Office Action Summary

09/517,434

RASTEGAR ET AL.

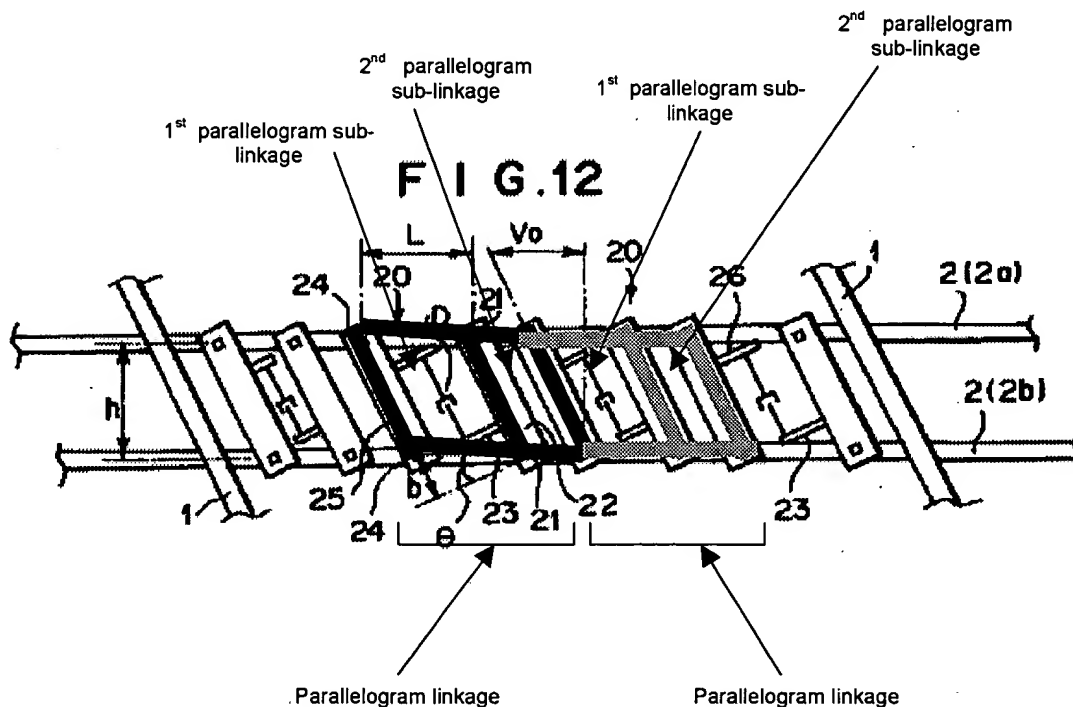
14. Claim 25 is rejected under 35 U.S.C. 103(a) as being unpatentable over Tsukagoshi in view of Prior Art figure 19. Tsukagoshi describes the invention substantially as set forth above, but does not include the limitation of the payload and base structure being components of a rocket. Prior Art figure 19 teaches the use of a payload and base structure 101, 102 as components in a rocket. It would have been obvious to one of ordinary skill in the art at the time the invention was made to have utilized the payload isolation system of Tsukagoshi in the rocket environment, as taught by Prior Art figure 19, in order to isolate vibrating rocket components. It is inherent that the effective weight (mg) of the payload will vary with time since the value of g will change during the rocket course.
